PREVOST

**SAFETY
RECALL**

Sr05-14A

DATE : November 2005	SECTION : 06
SUBJECT : NEW MULTIPLEX SOFTWARE PROGRAM AND INSTALLATION OF NEW WIPER HARNESS

FIGURE 1: CABLE ROUTING

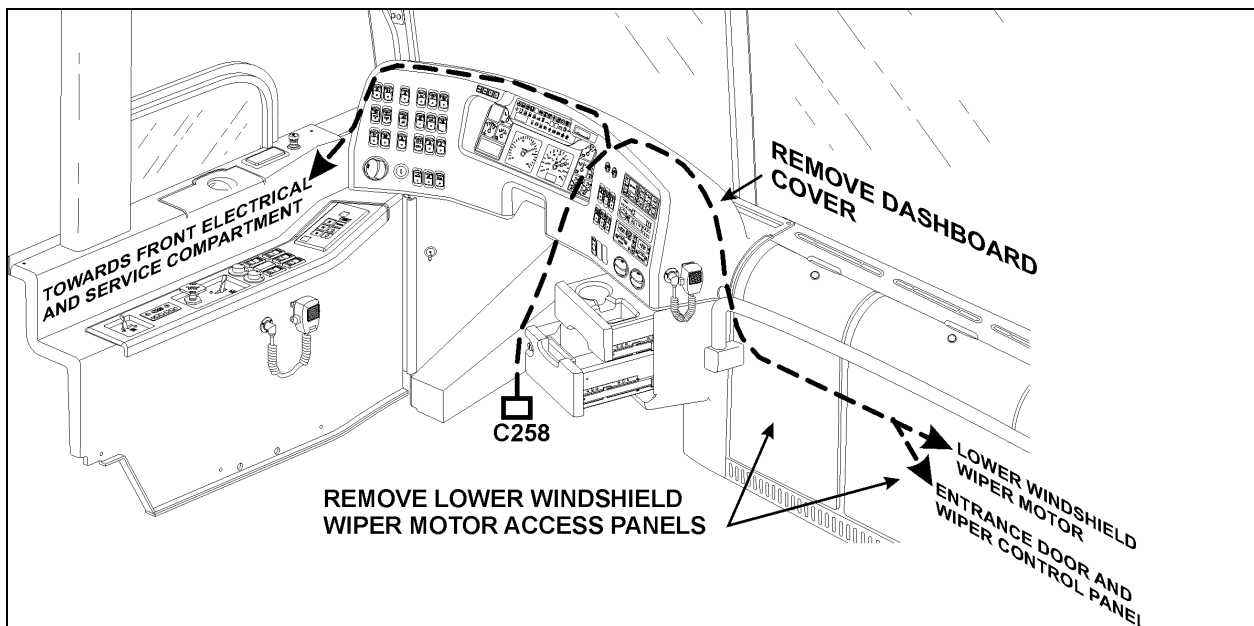
1. Remove dashboard cover and lower windshield wiper motor access panels (Refer to figure 1).

2. Disconnect connector C258 located at the base of steering column. Connect connector C258 of the new harness (066734) with cable coming from steering column multifunction lever.
3. Route cable end labeled "wipers" through inside of the dashboard and behind the driver's HVAC unit, towards the lower windshield wiper motor and the entrance door and wiper control panel; route the other end towards the front electrical and service compartment. Make sure the harness is properly secured using nylon ties by following the necessary precautions (Refer to figure 1).

FIGURE 2: FRONT ELECTRICAL AND SERVICE COMPARTMENT

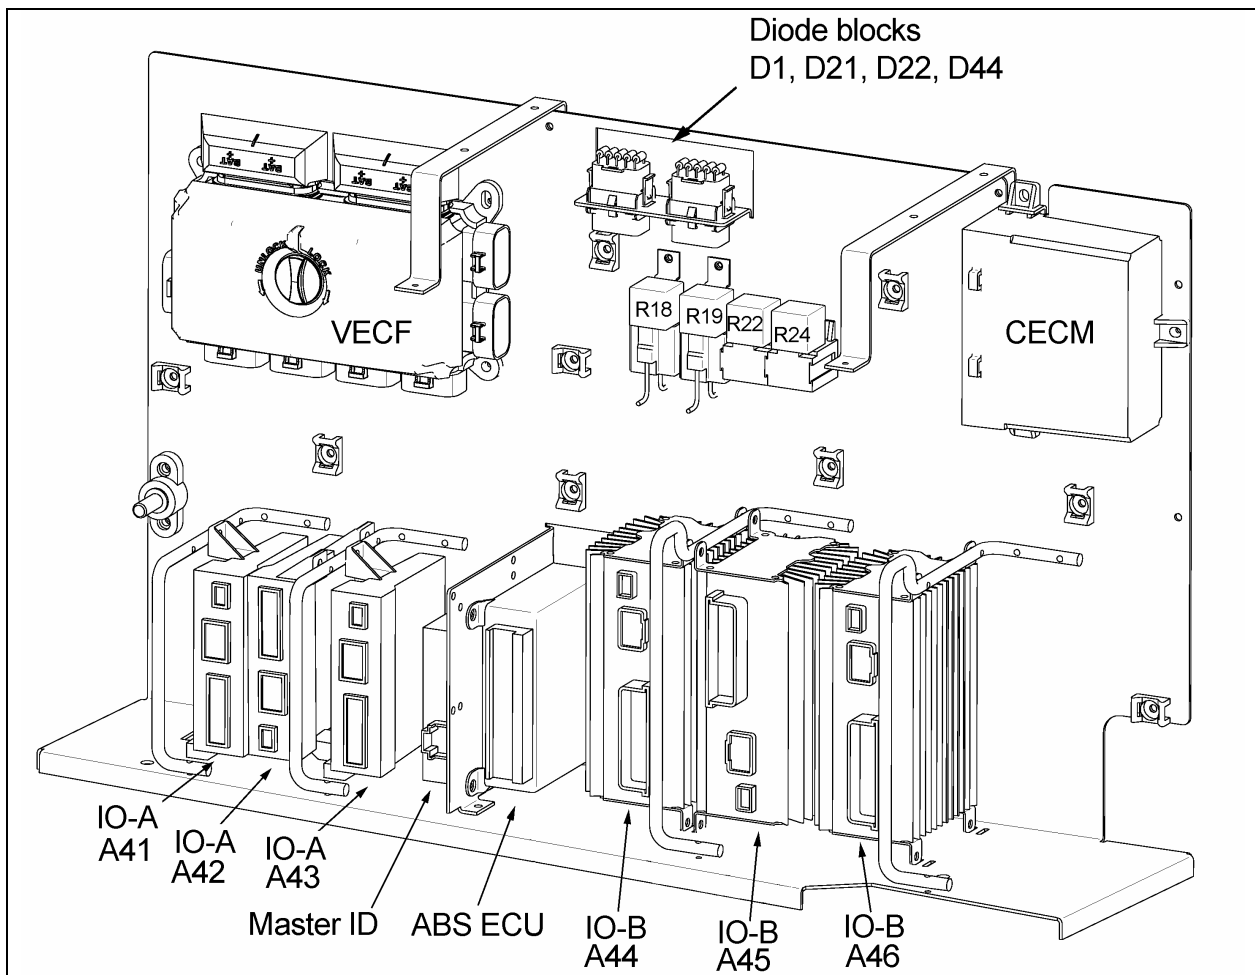
- Cut heat shrink tubing up (561918) into five 2.5-inch long pieces;
- Inside front electrical and service compartment, solder wire 24V17 of the new harness with wire 24V17 of RED connector VECF2-F; cover solder with heat shrink tubing;

- Connect wire 64A of the new harness into connector J1, socket number 5 of module A43;
- Remove wire 64A from connector J1, socket number 20 of module A43 then cover wire end with heat shrink tubing;

- Remove wire 59 from connector J1, socket number 8 of module A43 and cover wire end with heat shrink tubing, connect wire 59 of the new harness into connector J1, socket number 8 of module A43;

FIGURE 3: ENTRANCE DOOR AND WIPER CONTROL PANEL

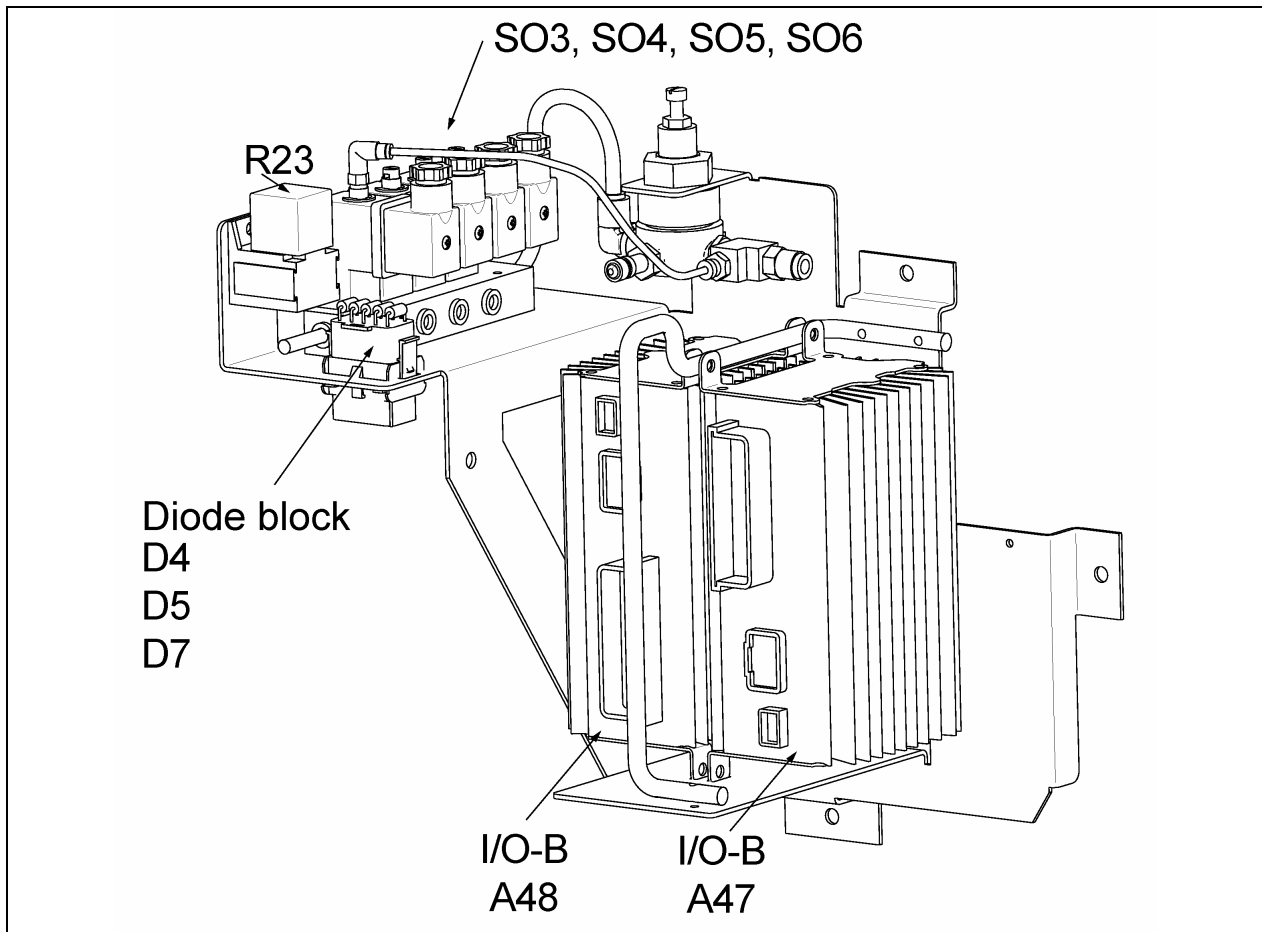
- Remove wire 53B from connector J1, socket number 4 of module A47 and insert into butt splice (562935); insert wire 53B of the new harness into the other end of the butt splice, crimp and heat both ends.
- Remove wire 53G from socket number 30 of relay R23, and insert into butt splice (562935); insert wire 53 of the new harness into the other end of the butt splice, crimp and heat both ends.
- Insert wire 31B of the new harness into socket number 30 of relay R23.

FIGURE 4 : VECF

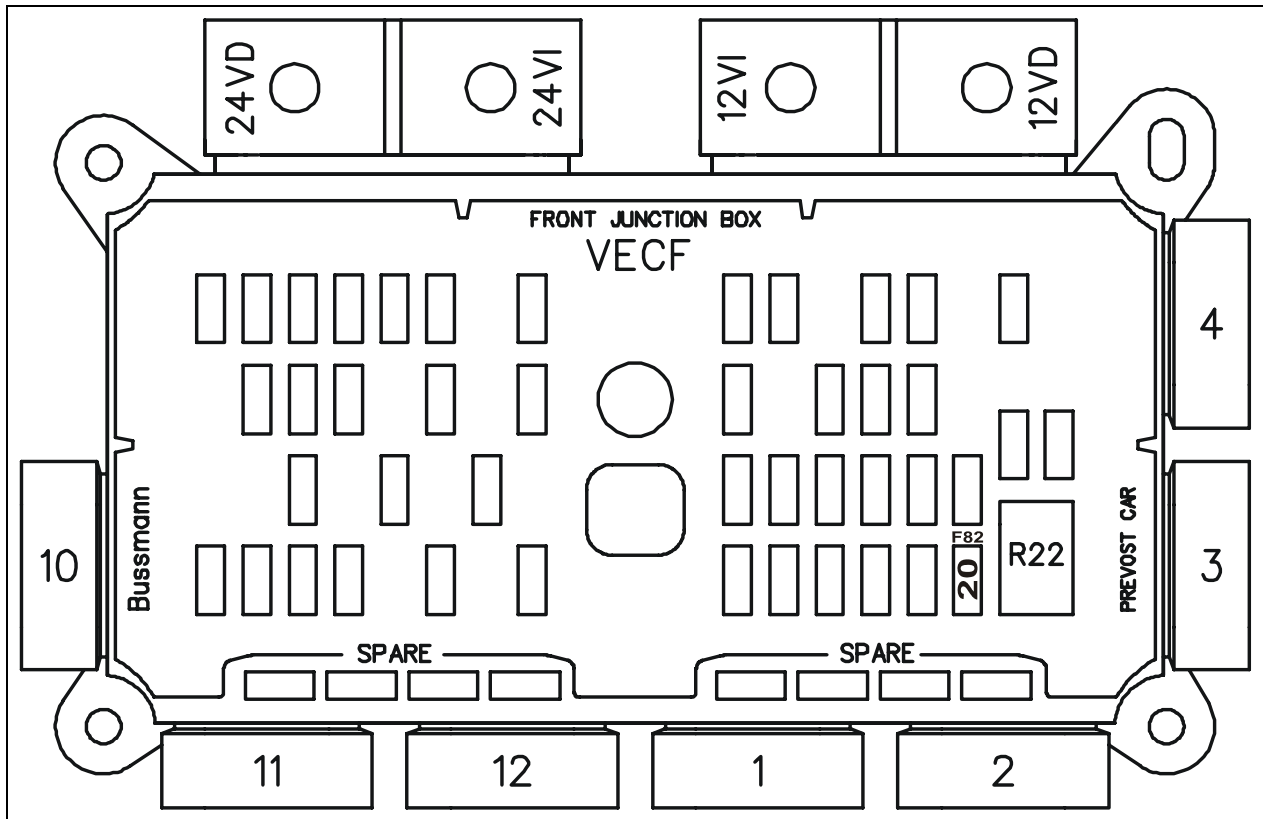
- Remove VECF cover then replace 15A fuse F82 with 20A fuse (563282). Mark up using permanent marker or self-adhesive sticker that new fuse must be 20 A (Refer to figure 4).
- Connect wire 53D of the new harness into connector J1, socket number 9 of module A44;
- Remove wire 53D from connector J1, socket number 9 of module A46 and cover wire end with heat shrink tubing;
- Connect wire 53C of the new harness into connector J1, socket number 4 of module A42. It is possible that wire 92 be already inserted into this socket, if this is the case; connect wire 92 into connector J1, socket number 2 of module A42 before inserting wire 53C in place;
- Remove wire 53C from connector J1, socket number 8 of module A42 then cover wire end with heat shrink tubing.
